## **CABINET MEMBER FOR ENVIRONMENT– 4 SEPTEMBER 2014**

### **PROPOSED PEDESTRIAN CROSSING – WINDMILL SCHOOL, MARGARET ROAD, HEADINGTON**

**Report by Deputy Director for Environment & Economy (Commercial)**

**ANNEX 1**

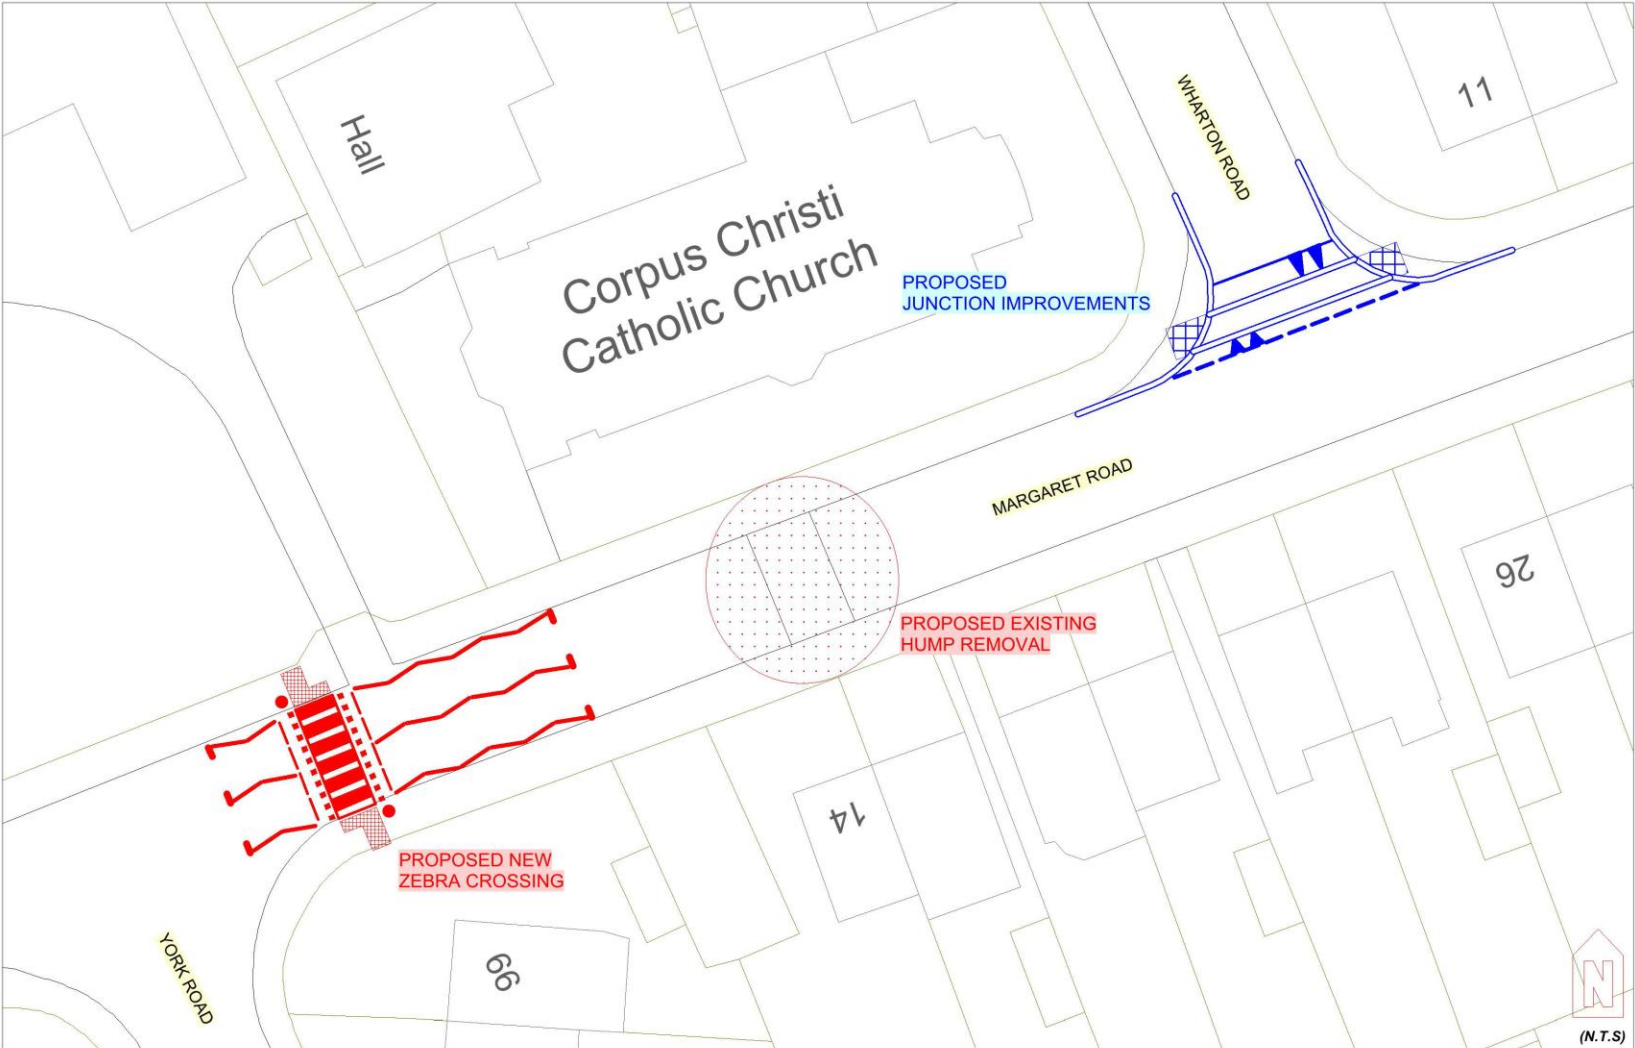
RESPONDENT	COMMENT	RESPONSE
Thames Valley Police	Have no objection to this proposal providing: The standard layout meets the requirements accepted within Local Transport Note 2/95 and that speed monitoring has taken place to determine current traffic speed meet these requirements.	Noted. The design of the crossing meets national standards.
City Councillor Dee Sinclair	<p>Understands the Priest of the Roman Catholic Church adjacent to Windmill School, who is concerned these plans will impact on funerals at the church as the access is where the crossing is planned.</p> <p>Following local concern about the expansion of the school and the impact on safety for children around this site, is in favour of a crossing. However, perhaps some more thought needs to be given to the location of the crossing, so close to York Road and the church access.</p> <p>Concerned about the limited time for responding as there are many residents in the area who have a view on this and may not be aware either of the proposals.</p> <p>Disappointed to note there is no formal way for City Councillors to be made aware of this type of work in their ward. Asks if there any way in which information can be accessed so that it can be shared on social media for example?</p>	<p>Officers have met with Fr Baggley to discuss his concerns and understand that he is now content that the crossing will not interfere unduly with the Church's activities.</p> <p>The proposed crossing is considered to be in the most suitable location for the needs of the school without interfering with local residents and the Church.</p> <p>The consultation, which was advertised in the vicinity of the proposed crossing and in the Oxford Times, had a response period of 5 weeks.</p> <p>It is not current practice to consult directly with District Councillors. Information is sent electronically to the District Council and to the local County Councillor who can disseminate as they feel appropriate.</p>

<p>City Councillor Ruth Wilkinson</p>	<p>Sight lines for traffic exiting York Road into Margaret Road already present difficulties due to parked cars, particularly at the start and end of the school day. The proposed zebra crossing is very near to that junction, and it is important that no safety hazard arises from schoolchildren suddenly stepping out into the road as vehicles turn the corner.</p> <p>Notes that the proposed zebra will not impact on existing parking bays but there is concern that the zig zag markings will prevent the use of that stretch of road for use by and dropping off of disabled persons by car outside the church.</p> <p>Has concerns about the likelihood of puddles forming each side of the proposed humps, this has happened throughout Headington Ward. Will drains be moved to accommodate this as I see no provision for it in the plans?</p> <p>Residents would like to have received letter drops from the County Council and a more formal consultation, as many only found out about it late.</p> <p>Residents would like to see a lollipop man or lollipop lady deployed at the zebra crossing if/when it is installed as they see this junction as a very busy one.</p>	<p>As part of the detailed design process the crossing will be subject to a Road Safety Audit when these issues can be investigated and addressed</p> <p>There will still be kerb space away from the crossing which could be used for dropping off disabled people who may also benefit from the crossing.</p> <p>This matter will be dealt with as part of the detailed design.</p> <p>Letters were sent to over 60 properties in the vicinity of the crossing (in Margaret Road, Wharton Road and York Road). In addition the proposal for the crossing was advertised on street and in the Oxford Times.</p> <p>This school has not had a School Crossing Patrol in recent years and it is unlikely that this will change, particularly as recruitment and retention is generally difficult.</p>

<p>Resident (York Road)</p>	<p>By installing a zebra crossing with belisha beacons there will be more poles on the pavement and a belisha beacon flashing 24/7 when it is being installed for the benefit of the school.</p>	<p>Masking the beacons so that they do not disturb adjacent residents will be considered as part of the detailed design.</p>

<p>A further objection to the zebra crossing is the double gates to my garage are on Margaret Road yet the zigzag lines of the crossing will cover this area. Is it not illegal to park on zigzag lines which I would need to do to access my garage.</p> <p>According to the school census large numbers of children are walking or cycling to school which will surely change once autumn arrives and the parents will be causing more parking problems than at present in the streets close to the school.</p> <p>Margaret Road is a rat run in a residential area is only helping to solve some of the excessive traffic problems in central Headington yet we are also going to be subjected to a proposed zebra crossing. The school has two entrances so why should the zebra crossing be at the eastern end of the school when the entire road is affected?</p>	<p>Whilst the proposed zigzag lines will be across the driveway there will remain an adjacent section of double yellow lines where it will be possible to stop whilst gates are opened.</p> <p>One of the reasons to introduce the crossing is to encourage more of the children attending the school to travel by means other than by car.</p> <p>It is partly because of the level of through traffic along Margaret Road that the crossing is required.</p> <p>The location of the crossing is designed to coincide with the principle pedestrian access into the school. The other entrance is for vehicles.</p>

<p>Resident (Wharton Road)</p>	<ol style="list-style-type: none"> <li>1. Does not believe that any of the speed humps in Margaret Road should be removed - we watch the cars and vans fly over those humps on a daily basis, completely disregarding them and the supposed 20mph limit - although they are certainly travelling slower than they do in Wharton Road.</li> <li>2. Has concerns about the lack of speed humps in Wharton Road which is a 'rat run' used extensively to avoid either the central Headington traffic lights or the roundabout on the ring road. We watch the cars accelerating once they come onto Wharton Road and there are several per day which are easily in excess of 30 mph, let alone 20, and this number massively increases during rush hour - this cannot be allowed to continue.</li> <li>3. Has concerns about the crossing proposed for where Wharton and</li> </ol>	<p>The hump which is being removed is being replaced by the new one which will have the zebra crossing on it.</p> <p>This proposal does not address the possible need for traffic calming on Wharton Road. However, this issue can be considered as part of the wider review of transport issues in Headington.</p> <p>The presence of the new crossing and</p>

<p>Margaret Roads meet. During the times when parents are dropping their children off or collecting them, they appear to lose all common and road sense. Parents are parking over driveways, parking on double yellow lines, parking on the corners so you cannot see what is coming etc and then moving off well in excess of the speed limit. Added to this mix is the traffic using Margaret and Wharton Roads as a rat run. It simply is not safe for any of us whether resident, pupil, parent, driver or pedestrian. I have serious concerns about how the increased number of pupils is going to impact on an already dangerous situation. I think you should remove the 2 hour parking allowance for at least 20 metres around the proposed crossing so that children on it or waiting to cross will be clearly visible.</p>	<p>associated zigzag markings should improve safety by creating an area clear of parked vehicles. Removal of limited waiting is unlikely to be effective in preventing short-stay parking by drivers collecting or delivering children to the school.</p>

<p>Resident (Margaret Road)</p>	<p>We will be inconvenienced by the changes but I have to stay they are broadly sensible now, let alone after the expansion of the school, which I also support.</p> <p>Please can the zebra crossing be a pelican? The pelican on London Road opposite Posh Fish works really well. Conversely, the inconvenience of a new pedestrian crossing to drivers is quadrupled by waiting pointlessly at a red light time and time again after the pedestrian has already crossed. Very annoying.</p> <p>It also means that impatient children don't have to wait for the green man (or indulge the temptation to jump the lights dangerously).</p>	<p>Noted.</p> <p>The crossing referred to is a zebra crossing and so will be the same as that proposed on Margaret Road.</p>
<p>Resident (Wharton Road)</p>	<p>I welcome all three of the changes detailed in the letter and think that this will improve the safety of children arriving at, and leaving Windmill School, especially as it grows further in size.</p> <p>I would however comment that I do not think the proposals go far enough. They address the very immediate issue of children crossing the road near to the school, but I feel that they will not sufficiently address two other issues that also significantly impact on children's</p>	<p>Noted.</p> <p>This proposal is not aimed at the wider issues referred to. However, these can be considered as part of the wider review of transport issues in Headington.</p>

<p>safety in the area of the school, namely traffic speed (especially on Wharton Road) and traffic volume (especially on Wharton Road, Margaret Road and York Road).</p> <p>I believe that both these issues could be addressed through the provision of one or two further flat-top road humps on Wharton Road. These would force traffic to slow down significantly, which would also make the road a far less attractive speedy rat-run to Windmill Road. They would also have the added benefit of improving safety for children attending St Andrews School and would ease road crossing for less mobile pedestrians, wheelchair users and people with pushchairs.</p> <p>I feel these changes would really compliment the changes detailed in your letter, ensuring that cars approaching the end of Wharton Road are already driving at acceptable speeds, rather than just break at the junction from around 40 mph. They would also reduce the traffic having to cross the raised pavement/ flat-top hump and the new zebra crossing, which will also make this more workable. I realise that this will involve additional expense, but I feel that they are very necessary and that now would be the right time to do this work.</p>

<p>Resident (Wharton Road)</p>	<p>I am grateful for the fact that the parking arrangements in Margaret Road alongside Corpus Christi Church will not be affected.</p> <p>I have serious doubts about the proposed location for the new pedestrian crossing. The junctions where York Road and Wharton Road intersect with Margaret Road are difficult ones for cars, lorries, cyclists and pedestrians. In terms of available road surface available both intersections have a degree of spaciousness; this would certainly be compromised with the proposals for the York Road Junction. I think it would make the junction more dangerous than it is now. This junction is a bit of a battle ground now; I think it would be made more</p>	<p>Noted.</p> <p>The proposed crossing is considered to be in the most suitable location for the needs of the school without interfering with local residents and the Church.</p>

<p>dangerous with the pedestrian crossing just round the corner.</p> <p>If the Pedestrian crossing were to be located at the lower entrance into the school site the crossing area would not be compromised; there is a much smaller amount of traffic coming in and out of the St Anne's Road and Margaret Road junction than at Wharton Road / Margaret Road or York Road / Margaret Road.</p>	<p>The location of the crossing is designed to coincide with the principle pedestrian access into the school. The other entrance is for vehicles.</p>
--	--	---
